SAKURA NOVI JSP22-09

Public hearing at the request of Sakura Novi Land Development LLC for Planning Commission's recommendation to the City Council of Preliminary Site Plan, Phasing Plan, Wetland Permit, Woodland Permit, and Storm Water Management Plan. The subject property is zoned TC-1 with a Planned Rezoning Overlay (PRO), which conditions development to the terms of a PRO Plan and Agreement. The site is approximately 15 acres and is located north of Grand River Avenue, south of Eleven Mile Road, and east of Town Center Drive (Section 23). The applicant is proposing to develop a mixed-use development including commercial retail, office, and restaurant uses, and multifamily residential units. The development has access to Grand River Avenue and Eleven Mile Road.

PLANNING REVIEW

Landscape markups

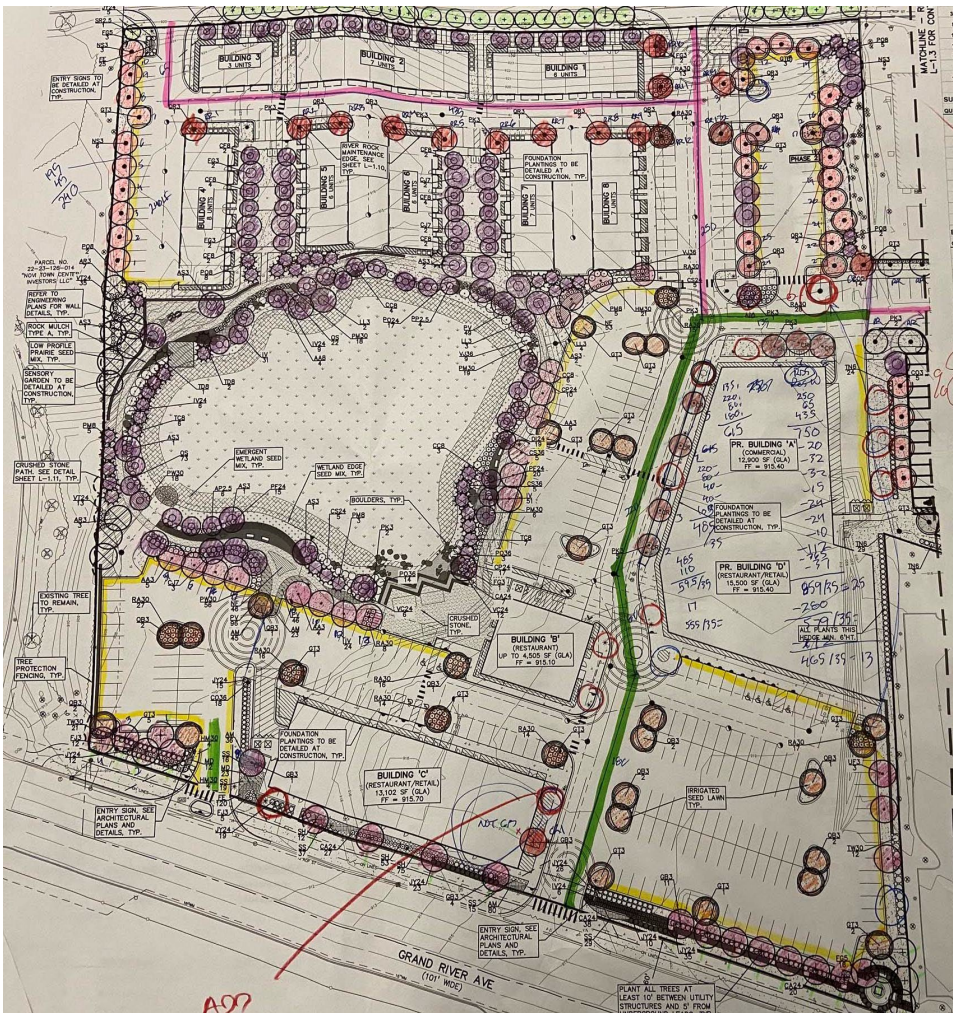
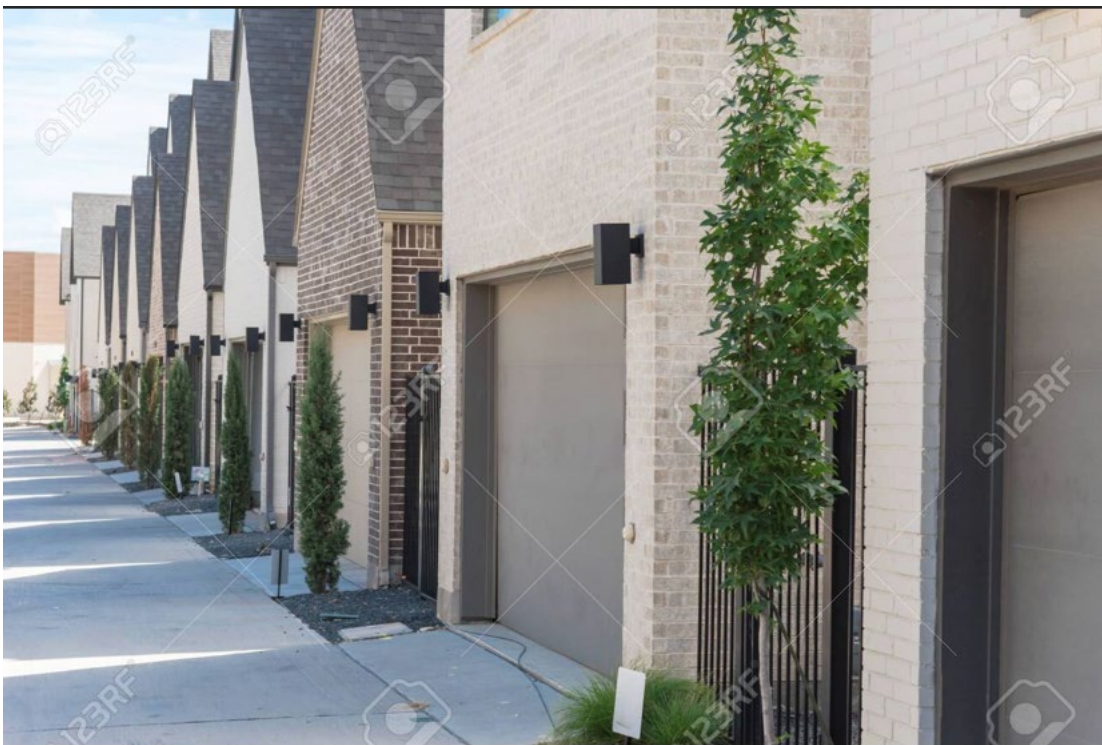
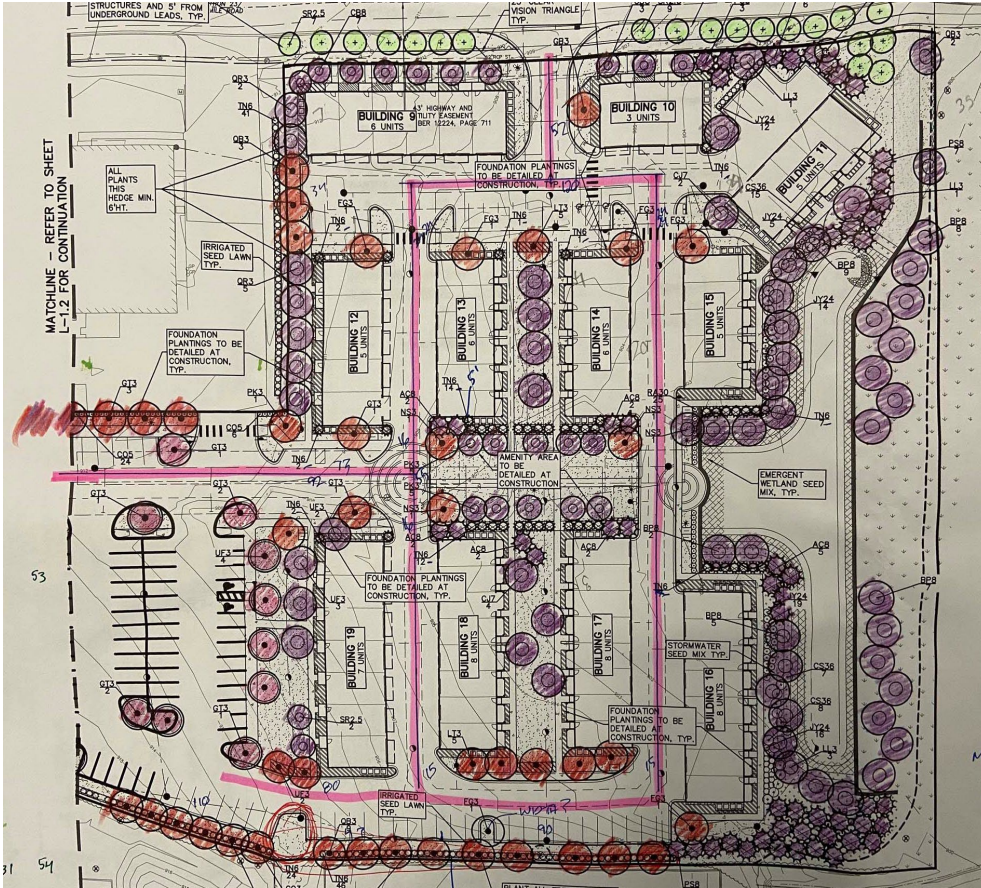
Item	Required	Proposed	Meets Code	Comments
				<p>section passing through that is counted in the residential calculations). The commercial accessway should actually be 711 lf (see the green line on the image of L-1.2 below).</p> <ol style="list-style-type: none"> 2. Please add the required number of trees, including in the islands on the north side of the east-west drive that don't have trees, on the east side of Buildings B & C, and more along Buildings A & D. 3. Only the entrance west of Building C and the stretch north of Building A/D need to be counted in this calculation. 4. Please indicate more area for getting air and water to the trees along the buildings than just the tree grates shown – Silva cells, trench drains, etc. with details. 5. The current proposed accessway perimeter landscaping is not sufficient and would require a landscape waiver.
Parking land banked	NA	None		
Other Landscaping

Pink line = Multi-family interior roadway
 Green line = Commercial accessway

Figure 1

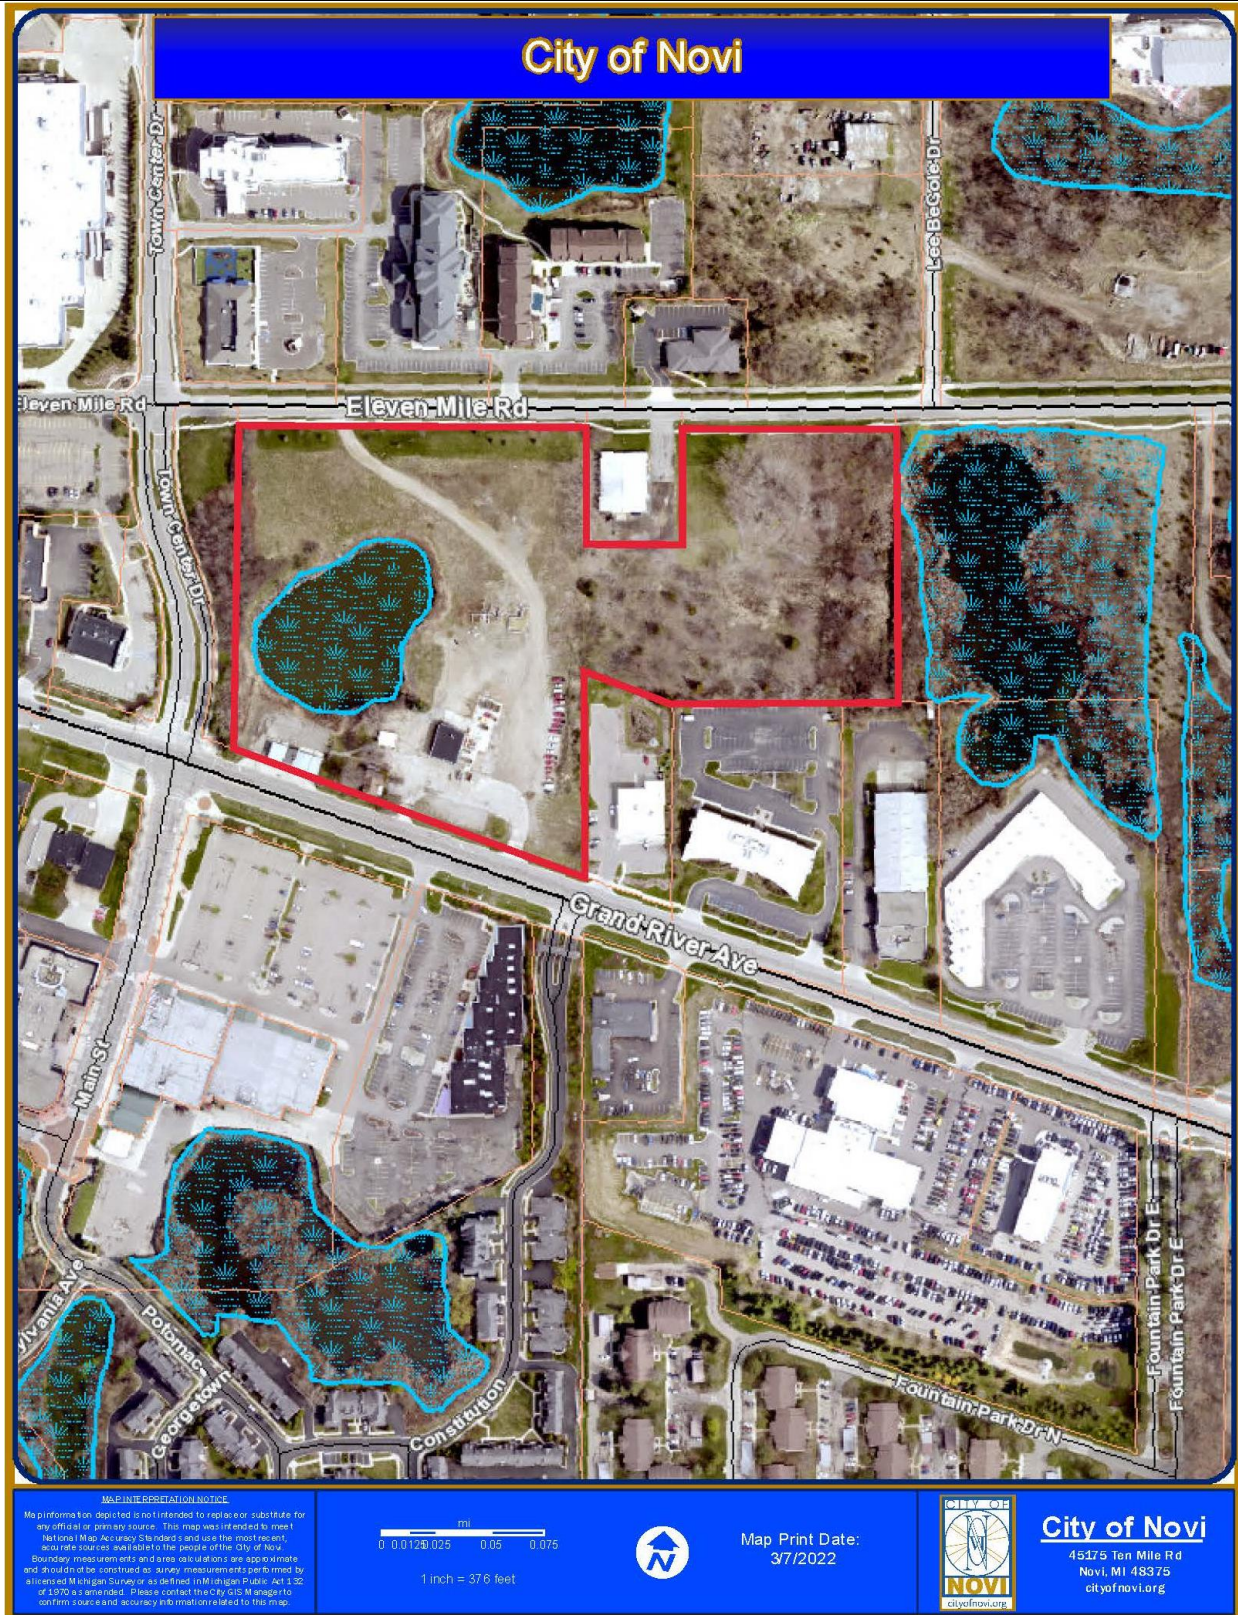
MSG reviewed The City of Novi Wetlands Maps and the Michigan Department of Environment, Great Lakes, and Energy (EGLE) Wetlands Map Viewer for the Site. The Site contains City-regulated wetlands (Figure 1). The Site also contains hydric (wetland) soil (Figure 2). Hydric soil is mapped by the U.S. Department of Agriculture, Natural Resource Conservation Service.

Figure 2.

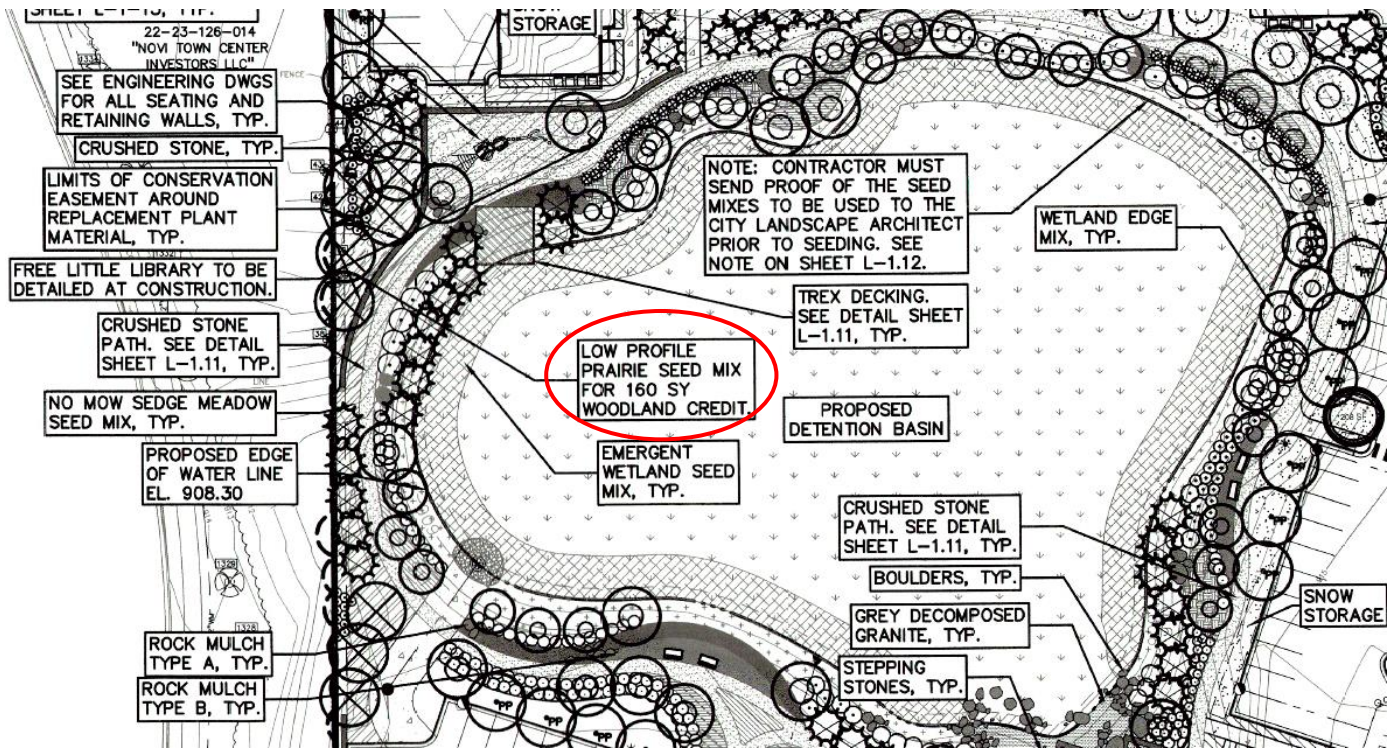
i. The Tree Protection Detail on page T-1.0 of the original site plan must be revised to show proper placement on the woodland protection fencing outside the CRZ of the tree (1-foot beyond the dripline).

1. **This comment has been addressed by the applicant on the revised site plan. Note, the Tree Protection Detail on page T-1.0 of the revised plan shows the tree protection fence at the dripline of the tree, when it should be placed at the critical root zone (1-foot outside the dripline); however, the text next to the detail indicates the tree protection fencing will be correctly placed 1-foot outside the dripline. See Figure 2.**

Tree Protection Fencing is incorrectly shown at the dripline, but text on the right indicates it will be placed correctly (1-foot outside dripline)

The tree fencing detail verbiage has been updated per the review. Please see sheets L-1.10 and T-1.0.

Figure 3. Page L-1.0

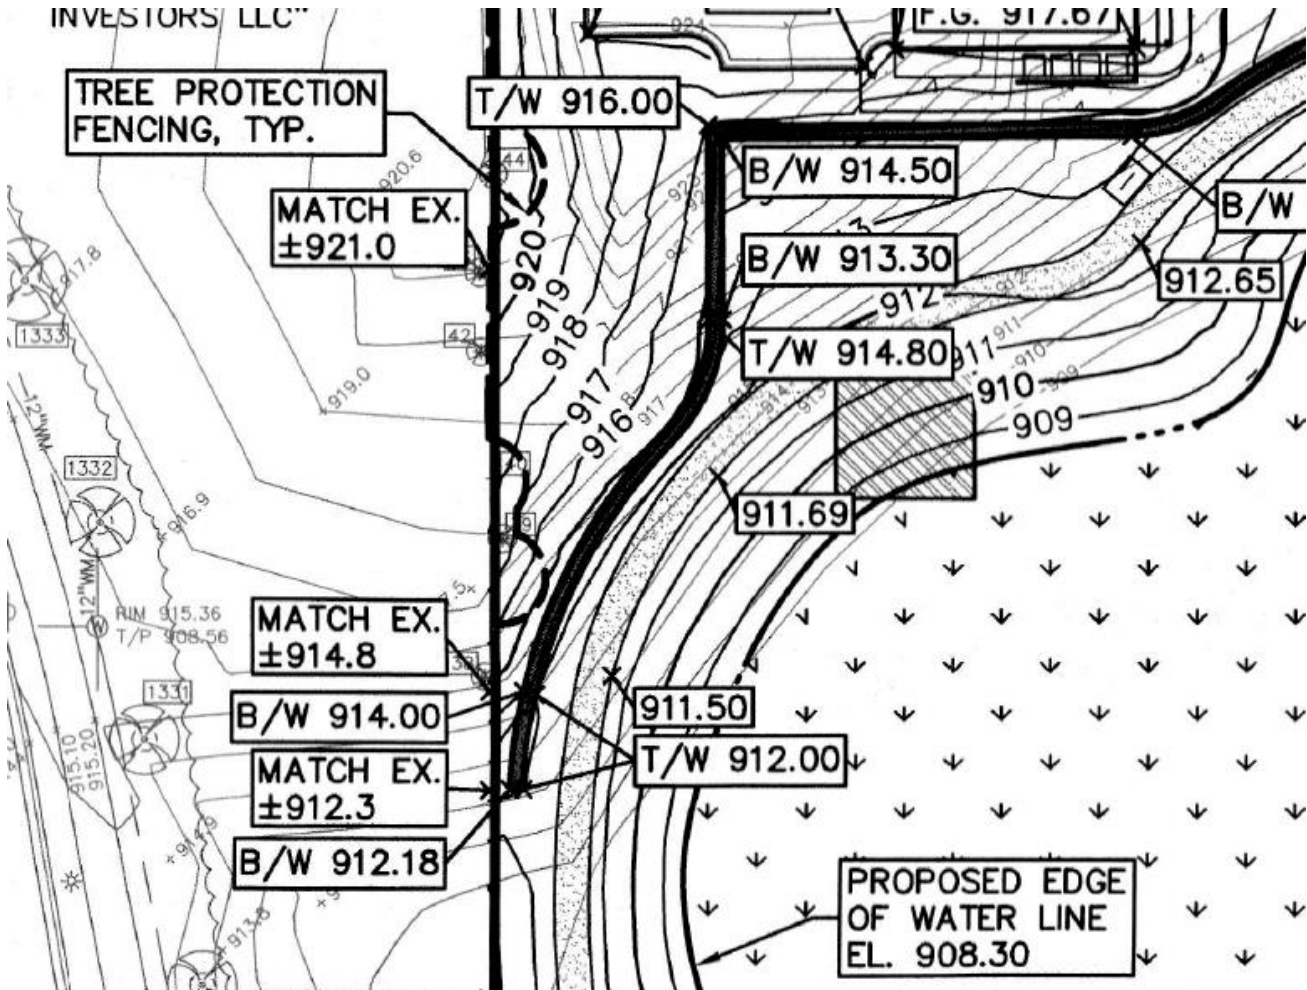
- i. Nine (10) 'Red Sunset' red maples – native
 - ii. Forty-eight (48) Compact American cranberry bush – native
 - iii. One hundred-sixty (160) square yards of native seed mixes - The applicant has provided the native seed mixes on Page L-1.12 of the site plan. The applicant has identified the area west of the wetland will be seeded to fulfil this credit. See Figure 3.

1 tree replacement credit will be fulfilled by seeding 160 SY of native groundcover species just west of the wetland, near the western edge of the development property

TREE PROTECTION FENCE DETAIL

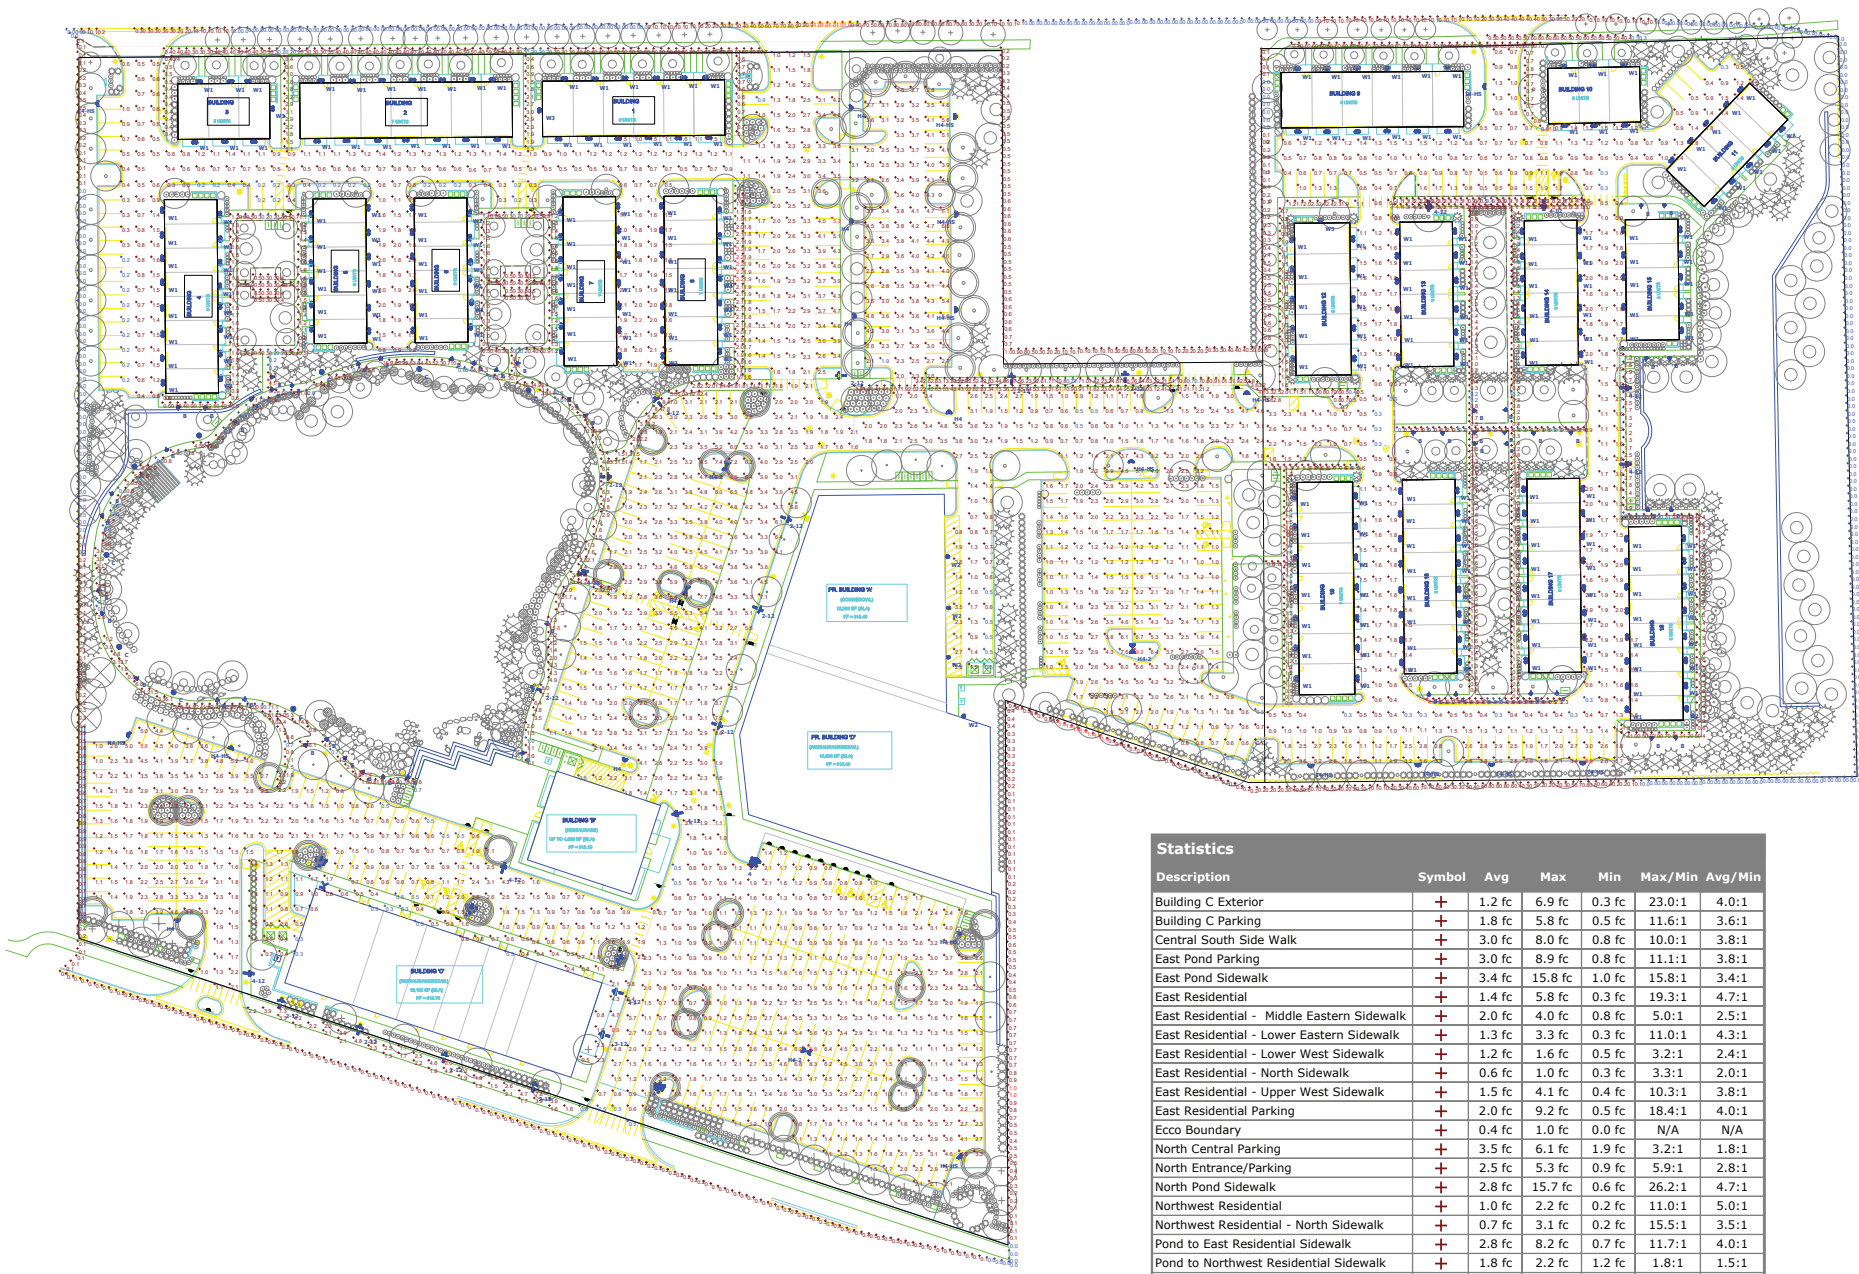
- i. **Grading plans on sheets C-3.1 and C-3.2 do not show the accurate location of the critical root zone of preserved regulated woodland trees and the tree protection fence appears to be within the critical root zone of preserved woodland trees.**
Revise plans to:
 - 1. Accurately depict the location of the critical root zone per Section 37-9(1)
 - 2. If tree protection fence must be located within the critical root zone of preserved regulated woodland trees, provide the woodland replacement credits required per the woodland replacement requirements outlined in

See **Attachment Sheet 3** for revised detail for critical root zone protection.
